**DEPARTMENT OF TRANSPORTATION
STATE OF GEORGIA**

FILE P.I. #0010379 **OFFICE** Design Policy & Support
Lowndes
GDOT District 4 - Tifton
Lowndes County **DATE** November 21, 2012
J. L. Newbern Middle School - SRTS
FROM  Brent Story, State Design Policy Engineer
TO SEE DISTRIBUTION
SUBJECT APPROVED REVISED CONCEPT REPORT

**DEPARTMENT OF TRANSPORTATION
STATE OF GEORGIA
REVISED PROJECT CONCEPT REPORT**

**City of Valdosta Public Schools
Construction of sidewalk from Pineview Dr. to J. L. Newbern Middle School.**

Detail of proposed Pedestrian crossing with R/R.

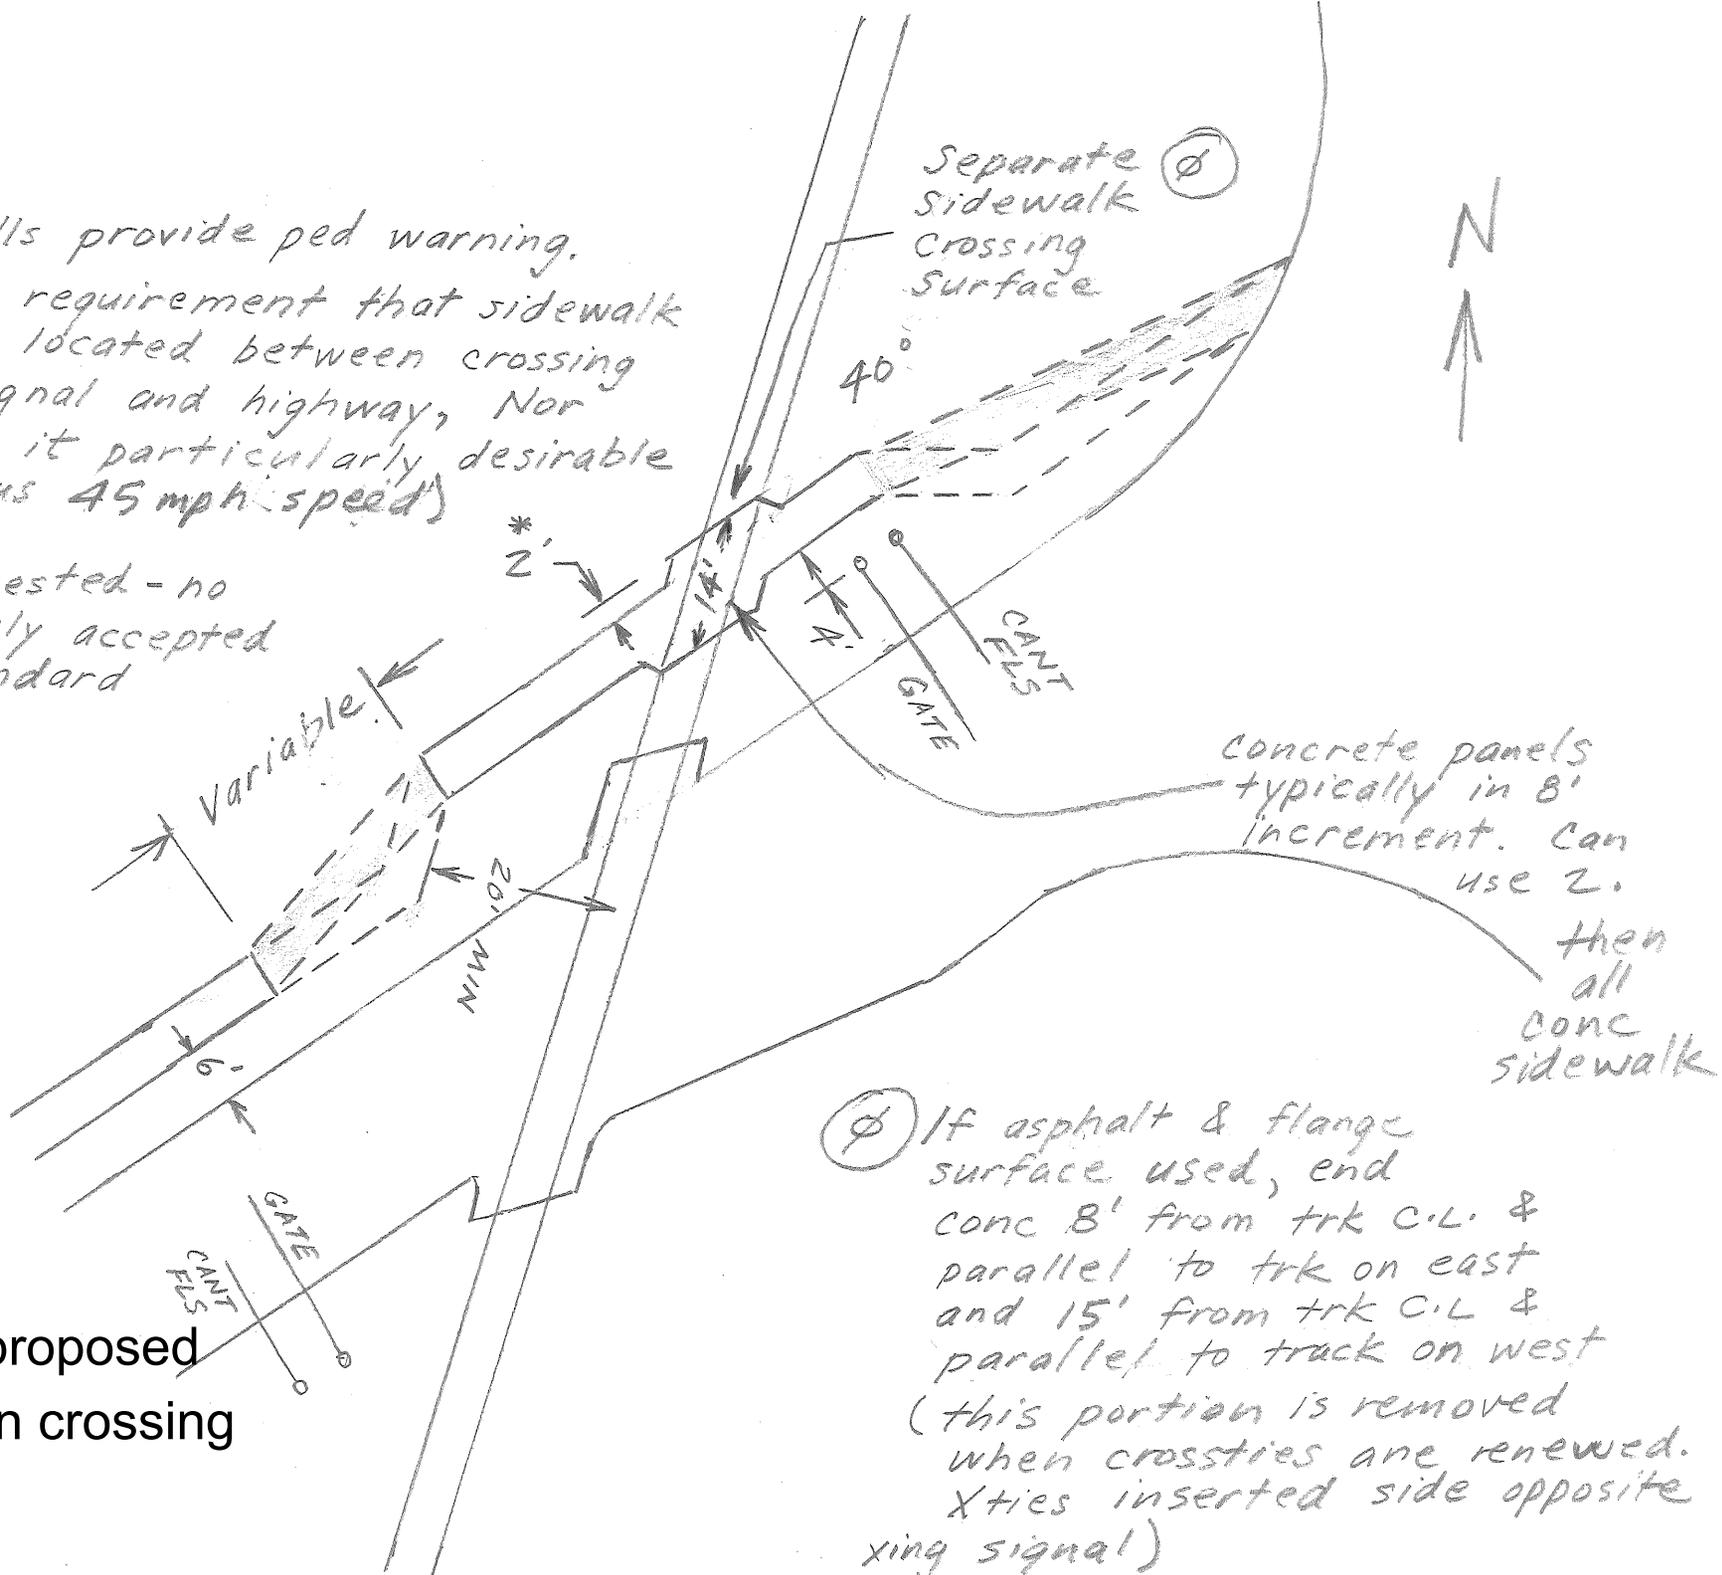
It would be desirable to have the sidewalk cross over the tracts rather than stopping just before the tracks, this would also be the railroad's preference. With that said, recommendations and comments are outlined below:

- 1) We recommend that the sidewalk be placed behind the existing railroad warning devices as you suggested. (instead of between the existing warning devices and roadway, 45-55mph)

- 2) It is not a requirement to an additional warning device just for the pedestrian users at this crossing. The bells on the existing warning devices will provide sufficient warning for the pedestrians.

- 3) It's my recommendation that the project be done without the additional pedestrian crossing gates for the following reasons
 - a) Because of the intersection angle of the railroad and roadway, if pedestrian gates were to be installed they would be about 45' apart. Which means when a gate is activated and a pedestrian is between both gates they would not have enough time to clear the second gate (meaning they would have to bend under to clear the gate)

- b) Train speed at this crossing is 10mph and only has 2 trains per day.
 - c) Each pedestrian gate would cost about \$50k, for a total of \$100,000. I don't see the need to spend this much money for pedestrian crossing only in this situation.

- d) You can consider adding flashing lights only on both sides of the track, this would cost about \$15,000- \$20,000. But again this is optional not a requirement.

- Bells provide ped warning.
- No requirement that sidewalk be located between crossing signal and highway, Nor is it particularly desirable (plus 45 mph speed)

⊕ If asphalt & flange surface used, end conc 8' from trk C.L. & parallel to trk on east and 15' from trk C.L. & parallel to track on west (this portion is removed when crossties are renewed. Xties inserted side opposite xing signal)

- 1) install sidewalk at crossing as shown in attachment sketch.
- 2) Existing warning devices is sufficient to satisfy proposed sidewalk at crossing.
